<b>DOCKET</b>	
<b>09-AFC-6</b>	
DATE	JUN 23 2010
RECD.	JUN 25 2010

**Subject:           Comments on Draft EIS/SA for the Solar Millennium Blythe Solar Power Plant  
 (the “Solar Millennium Project”)**

**Exhibit 1: Conceptual Gen-tie Diagram**

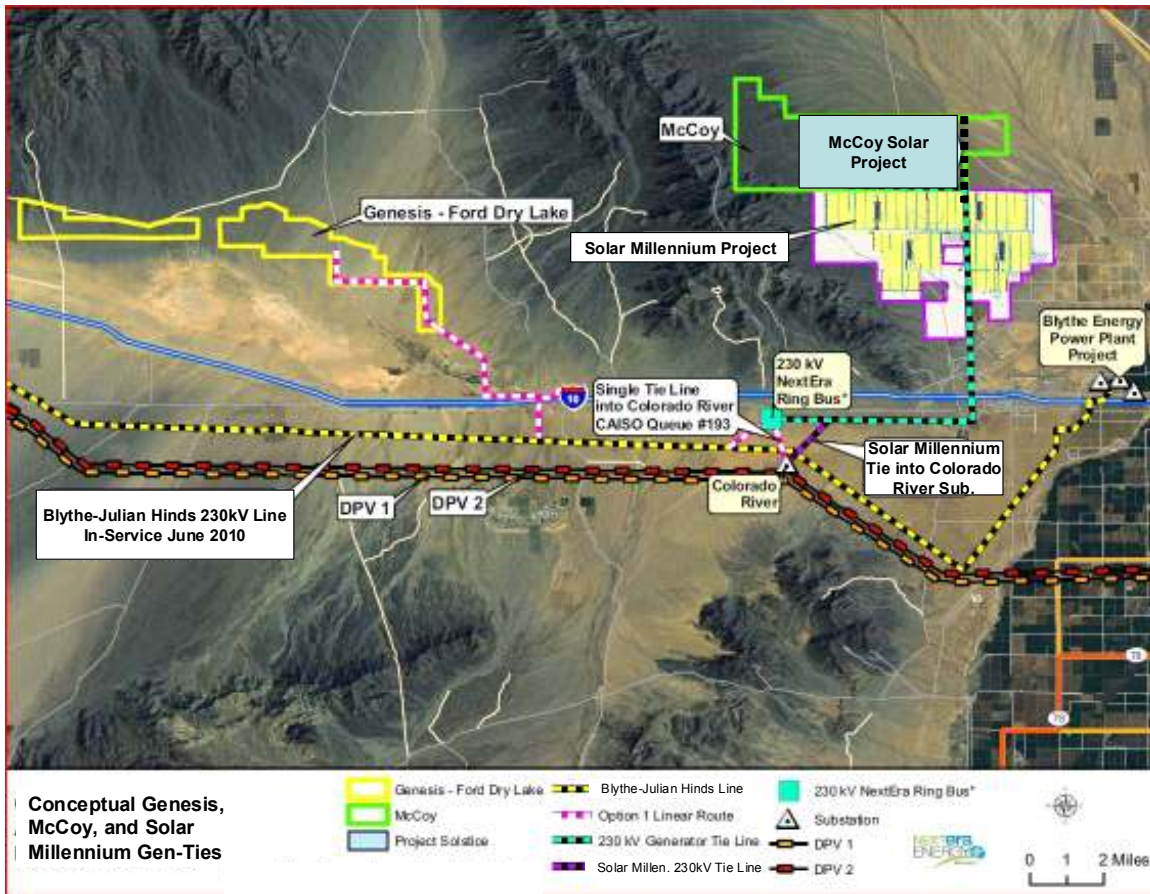
In order to minimize the environmental impacts associated with solar project development, NextEra Energy Resources, LLC (“NextEra”) and SolarReserve, LLC (“SolarReserve”) request that the Bureau of Land Management (“BLM”) and the California Energy Commission (“CEC”), give consideration to establishing a North-South utility corridor through the Solar Millennium Project site (the “Utility Corridor”) to accommodate an additional double circuit 230kV line which would run in parallel to the Solar Millennium’s planned double circuit 230kV gen-tie to the SCE Colorado River Substation (reference attached conceptual drawings, Exhibits 1 & 2).

This Utility Corridor and additional double circuit 230kV line would allow projects to the north of the Solar Millennium Project to access Colorado River Substation with less environmental and land use impacts than alternatives which would involve creating additional, separate transmission line corridors around Solar Millennium’s Project either to the west or to the east. NextEra would also provide a similar transmission right-of-way access along the eastern boundary of McCoy as shown in Exhibit 1, attached. By establishing the Utility Corridor, linear facilities from projects to the north would be combined and minimized, consistent with BLM and CEC best practices guidance for desert renewable energy projects.
